SUBJECT: NRC SPECIAL INSPECTION 50-247/2000010- STEAM GENERATOR TUBE
FAILURE

Report No. 05000247/2000-010

Indian Point 2 Nuclear Power Plant
NRC Inspection Report 05000247/2000-010

Figure 12 - 1997 scan

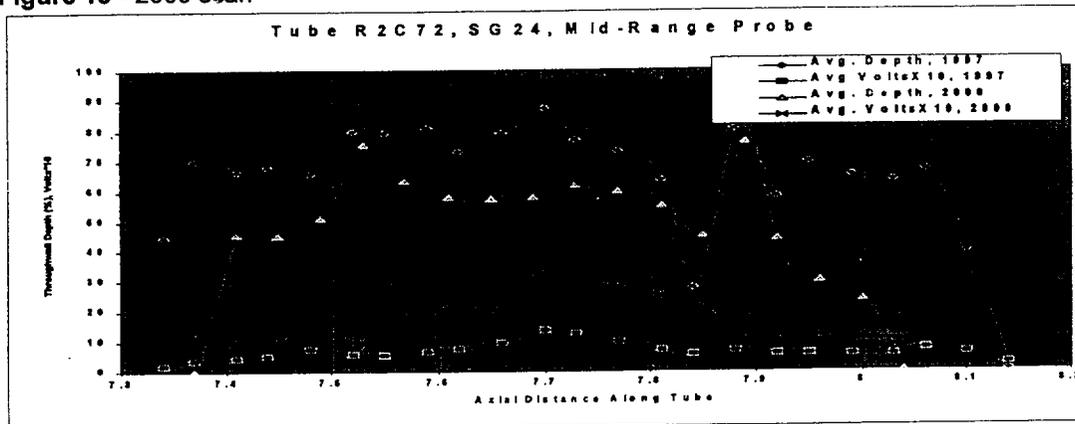
3. R2C72 in SG 24 - Figure 12, shows the c-scan plot of the 1997 data, there is considerable noise present. The crack is sitting in a ridge of noise, and barely extends above a ridge of deposits. For comparison the c-scan plot for the 2000 data is included as Figure 13 Figure 14 shows the profile The crack barely extends above a 1-volt amplitude for a short length, and this is the only part of the crack that we can profile reliably. The depth estimate based on 1997 data is 79.2 % TW.

Figure 18 - Crack in tube 2-67 of steam generator 24, found in 1997.

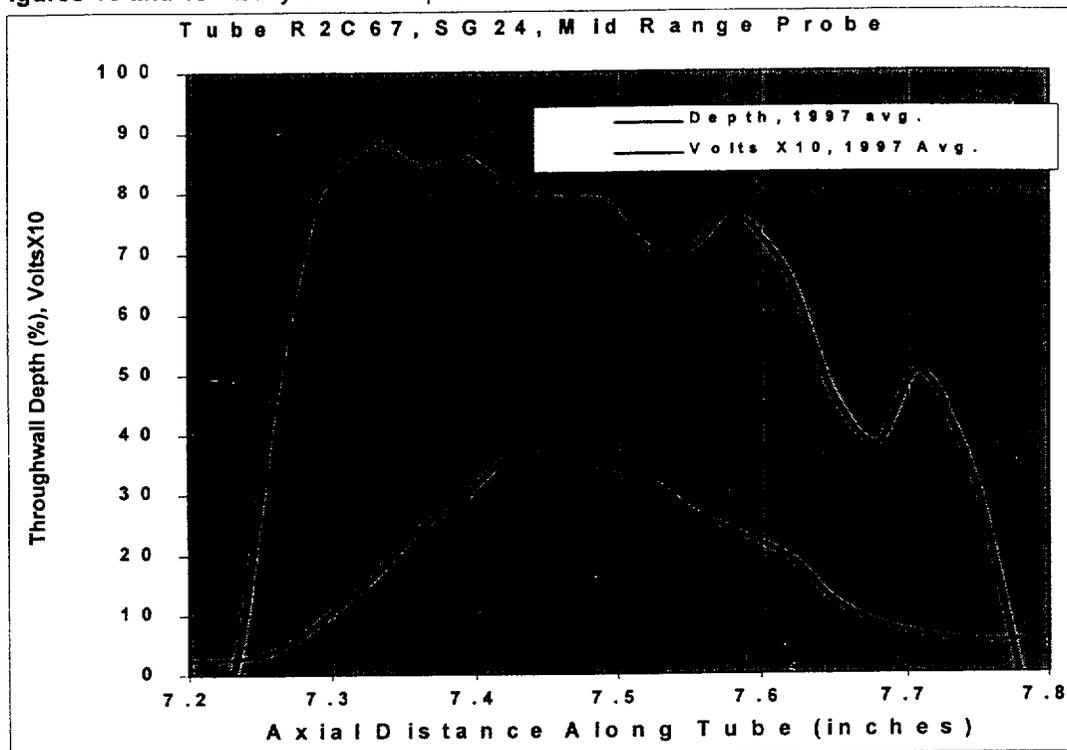
Figure 18 shows the c-scan plot of the 1997 data from R2C67, the crack sits beside a ridge, in a valley, and is in an easily detectable portion of the tube. The large amplitude of the voltage signal, in relation to the standard calibration notch would indicate that this is a "mature" crack. No year 2000 data is available since the tube was plugged in 1997. Figure 19 shows the profile. The depth estimate based on 1997 data is 87.5% TW.

The comment made by the licensee regarding the noise levels in R2C67 being bounded by the response of the samples used in the EPRI studies is believed irrelevant. The R2C67 flaw was indicated by the c-scan to be not associated with noise ridges.
